Access Compliance Report

Public Rights-of-Way

Intersection ID: 11642	Main Street: N_POPLAR_ST	Cross Street: W_9TH_ST	Location: S
ADA ID: A37F3AA80A4B	Ramp Type: PerpDiag	Initial Pass/Fail: Fail	Overall Compliance: No
		Severity Score: 25

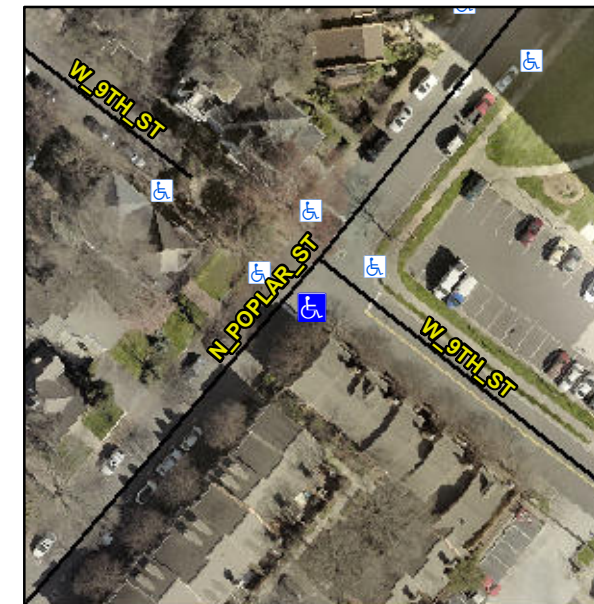
R304.2.2, R304.5.3

Compliance	Description	Data	Compliance	Description	Data
N/A	Ramp Length (in)	55.0	No	Ramp Slope (%)	9.6
Yes	Ramp Width (in)	56.0	No	Ramp XSlope (%)	5.6
N/A	Flare Type LT	N/A	N/A	Flare Type RT	N/A
N/A	Flare Slope LT (%)	N/A	N/A	Flare Slope RT (%)	N/A
N/A	Flare Traversable LT?	N/A	N/A	Flare Traversable RT?	N/A
N/A	Landing Length (in)	N/A	N/A	DWS Provided?	N/A
N/A	Landing Width (in)	N/A	N/A	DWS Contrast?	N/A
N/A	Landing Slope (%)	N/A	N/A	DWS Length (in)	N/A
N/A	Landing X Slope (%)	N/A	N/A	DWS Full Width?	N/A
N/A	Landing Curb? (Y/N)	N/A	N/A	DWS Offset (in)	N/A
N/A	Shared Landing?	N/A			
N/A	Gutter Ponding?	N/A	N/A	Gutter Slope (%)	N/A
N/A	Gutter Lip Ht (in)	N/A	N/A	Gutter X Slope (%)	N/A
N/A	Painted X Walk1?	No	N/A	Painted X Walk2?	No
	X Walk 1 Direction	To NE		X Walk 2 Direction	To NW
N/A	X Walk 1 Width (in)	N/A	N/A	X Walk 2 Width (in)	N/A
	X Walk 1 Slope (%)	9.0		X Walk 2 Slope (%)	4.3
	X Walk 1 X Slope (%)	1.5		X Walk 2 X Slope (%)	0.6

Remove & Replace Curb Ramp With Two New Directional Ramps or Equivalent.
